Re: Partial Approval of MSD's 2012 Integrated Overflow Abatement Plan Project
Modification Request

2012 IOAP Project Modification

Subject: 2012 Integrated Overflow Abatement Plan (IOAP) Modification
DOJ Case No. 90-5-1-1-08254

I-64 and Grinstead Drive Storage Basin

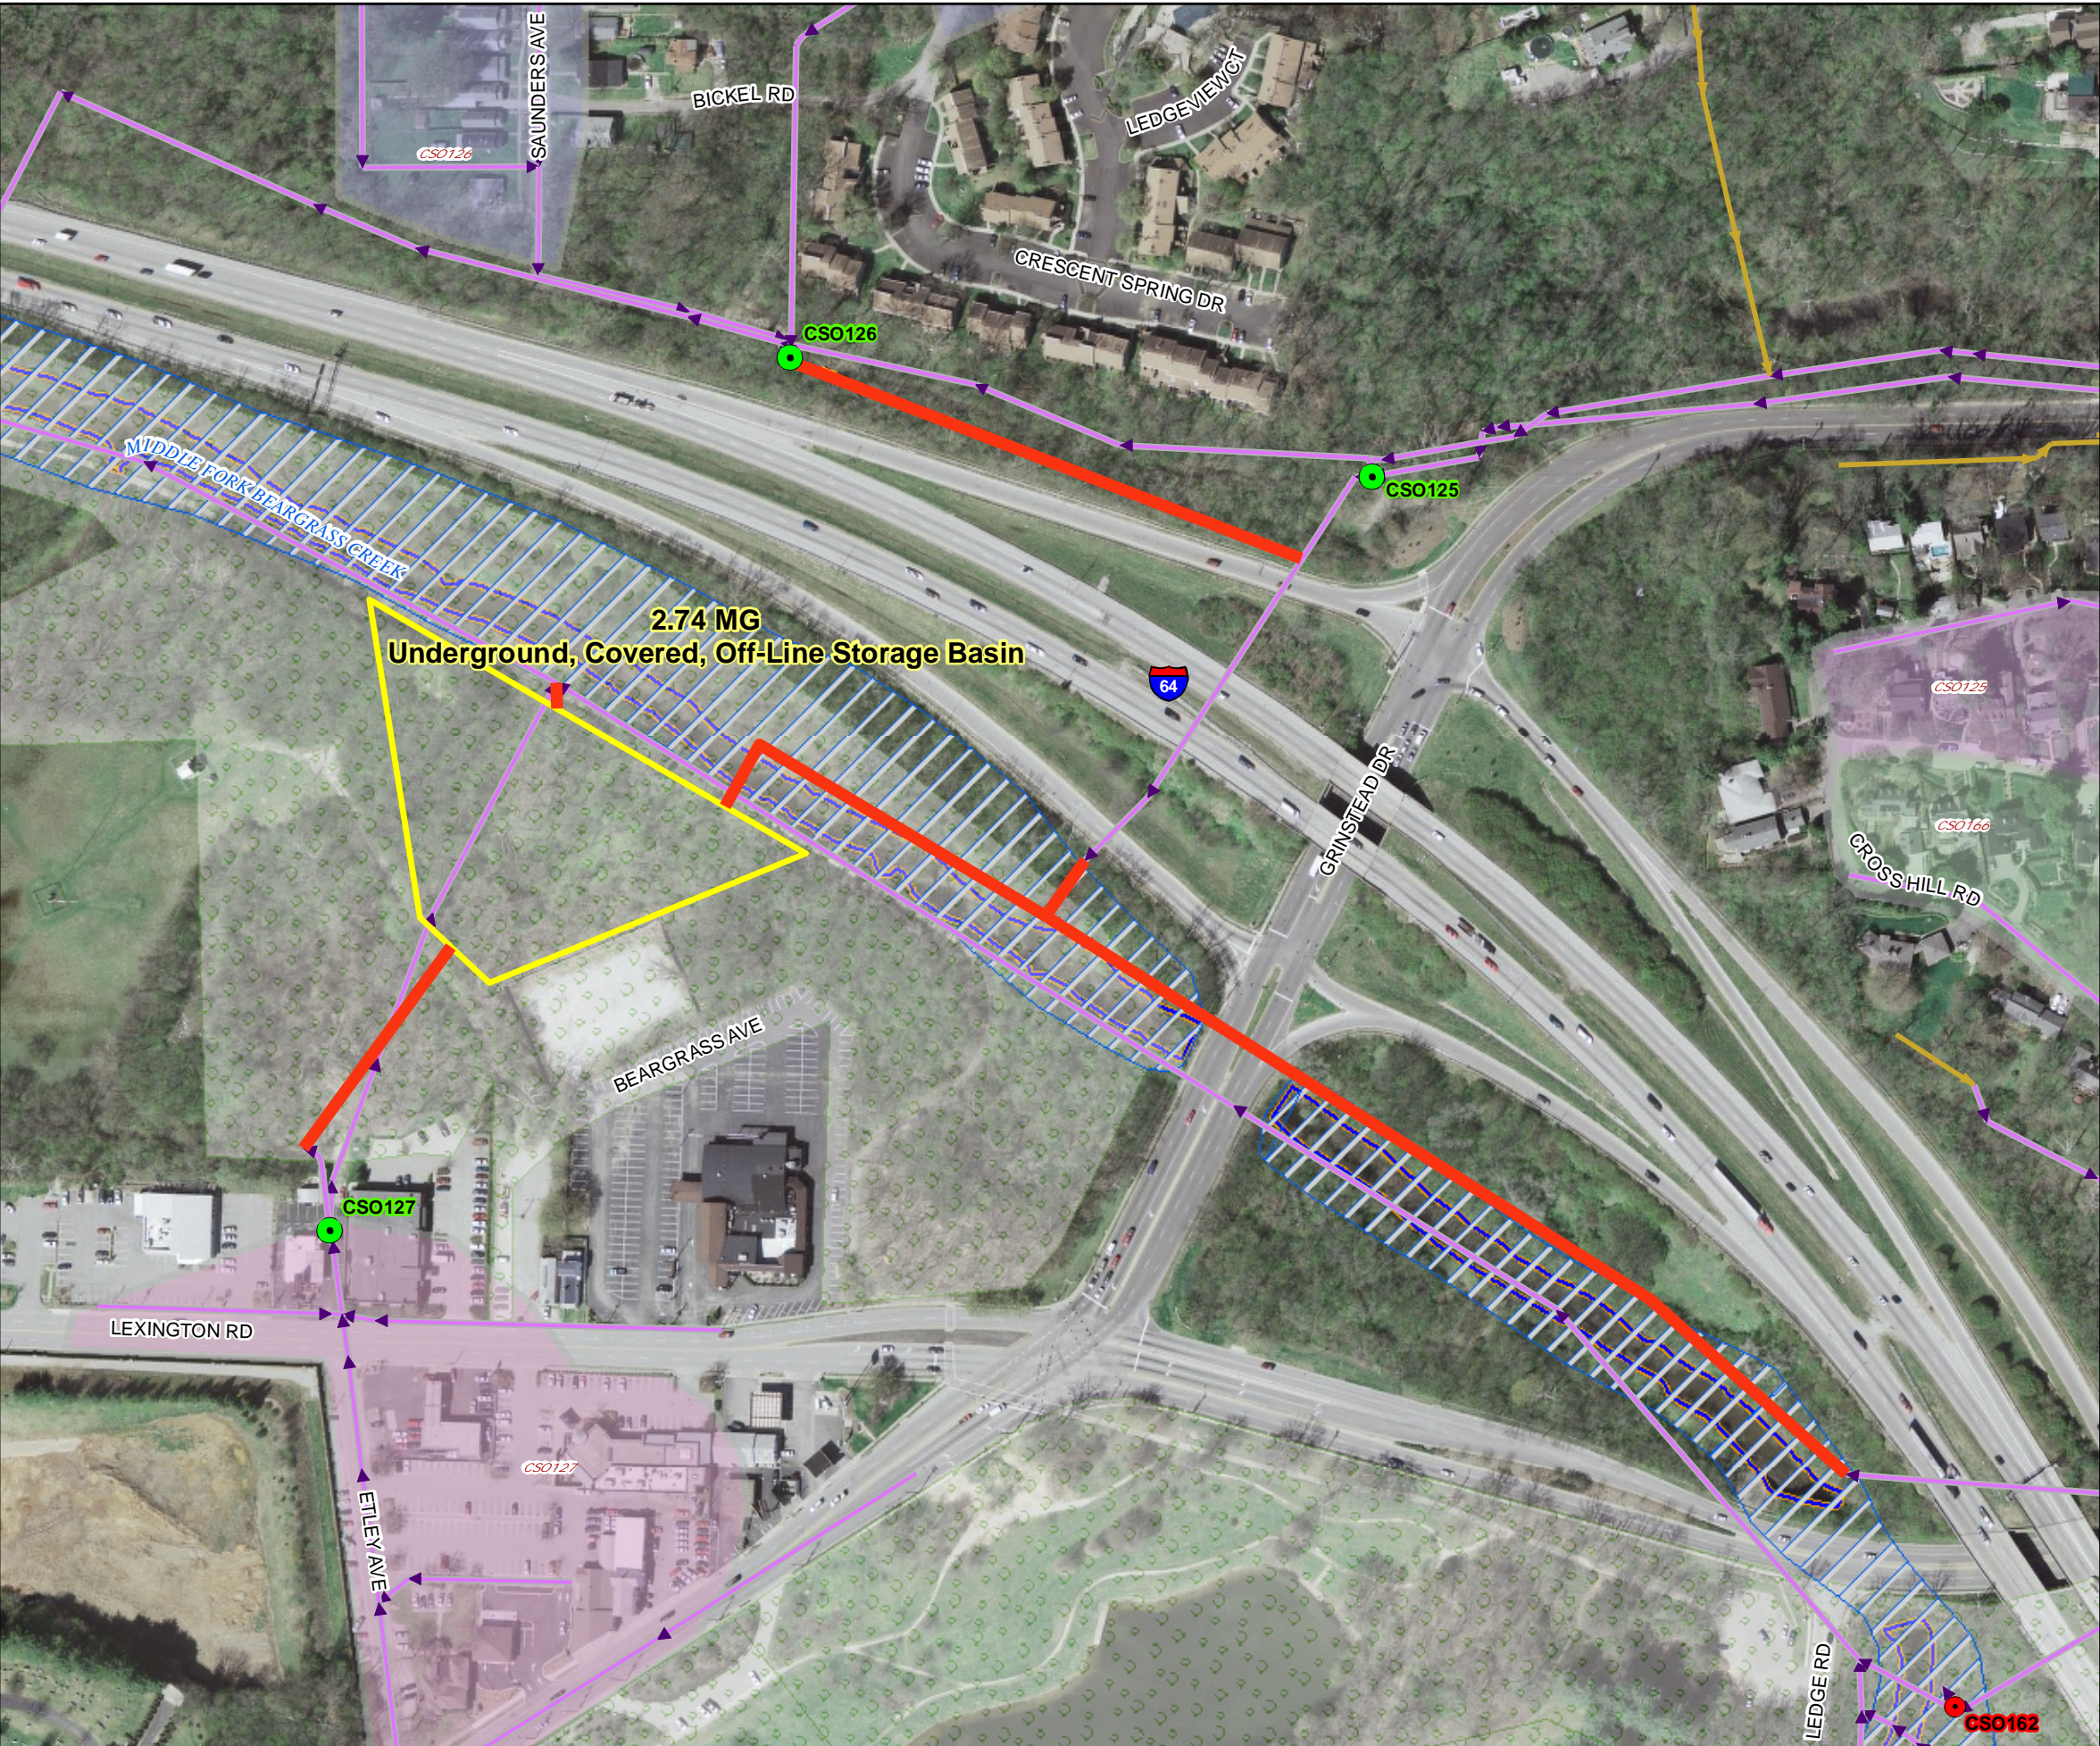
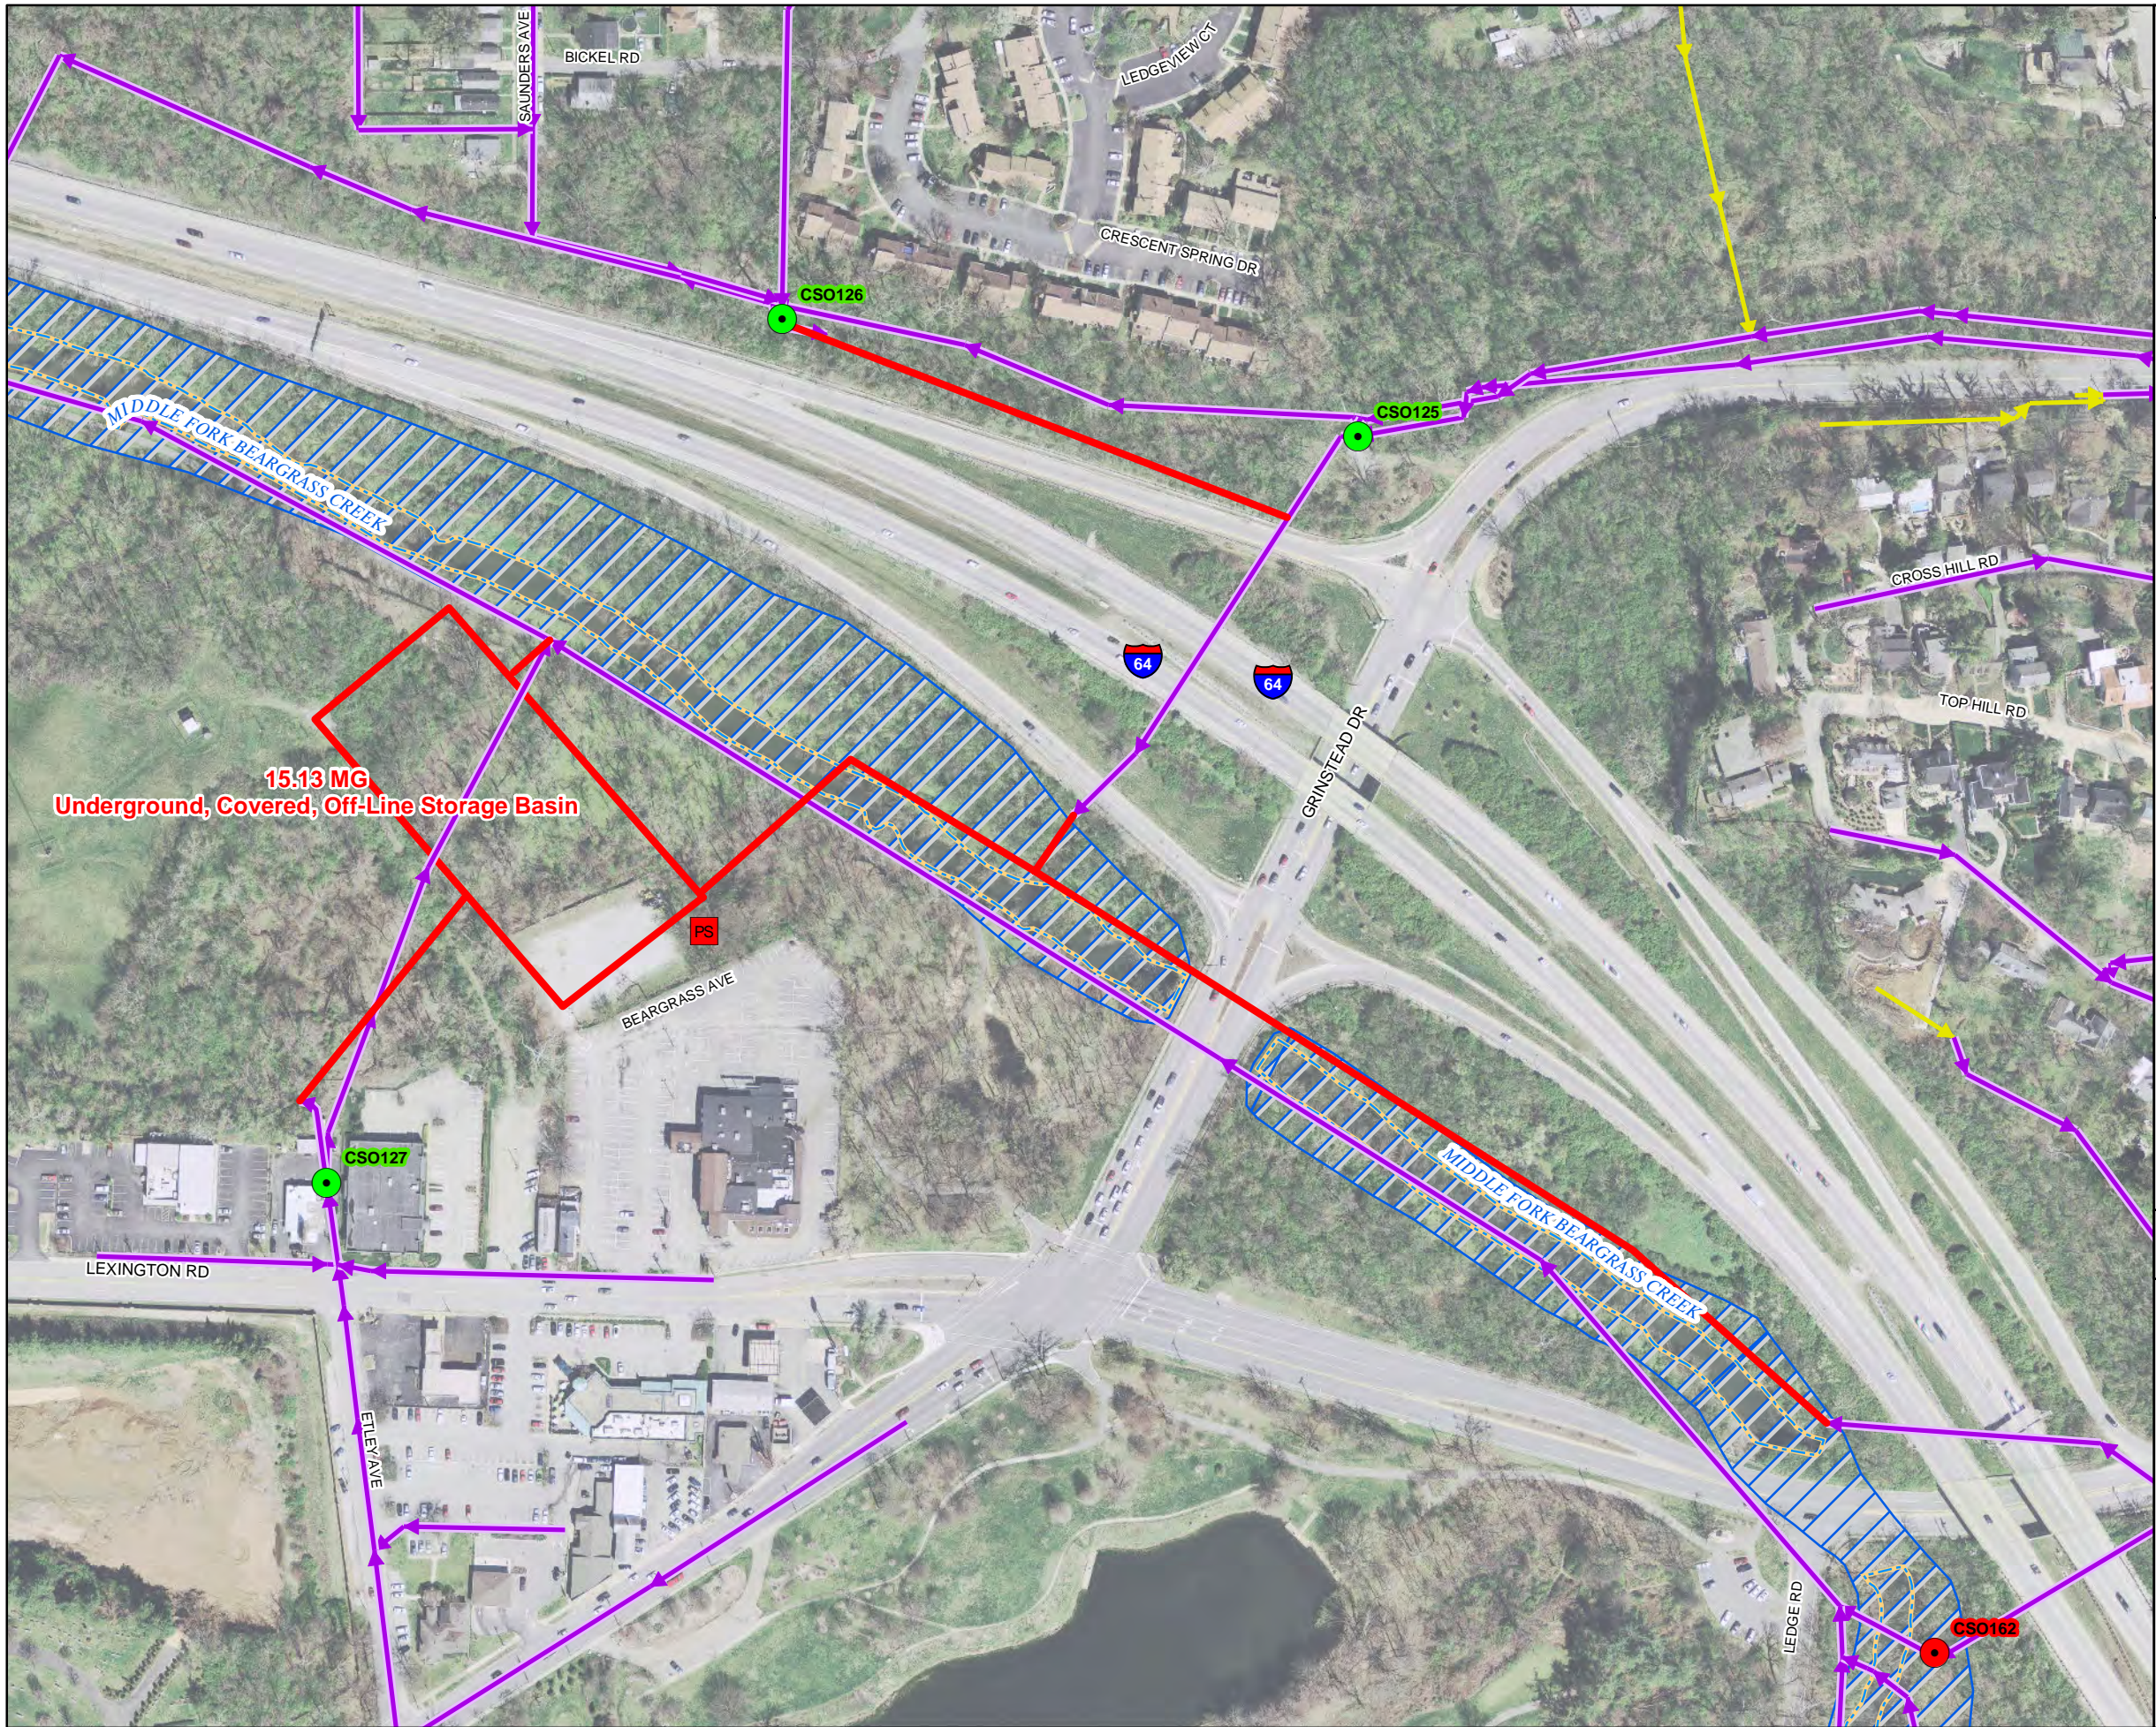
The project modification involves the construction of a 15.33 MG storage basin to be completed by December 31, 2020, with a four overflows per typical year level of control. Moving the schedule into 2020 will allow for the proper construction of such a large basin and the incorporation of the green infrastructure within the drainage area of the four combined sewer overflows controlled by the basin. MSD is analyzing potential green infrastructure projects to possibly reduce the size of the storage basin.

Based on the results of the re-calibration, a level of control analysis was conducted on the I-64 and Grinstead Storage Basin. The level of control analysis showed that the basin size of 15.33 MG would meet a level of control of four overflows per year and provide the highest benefit/cost ratio. Therefore, MSD proposes to change the I-64 and Grinstead Drive Storage Basin solution from a 2.74 MG basin to a 15.33 MG basin.
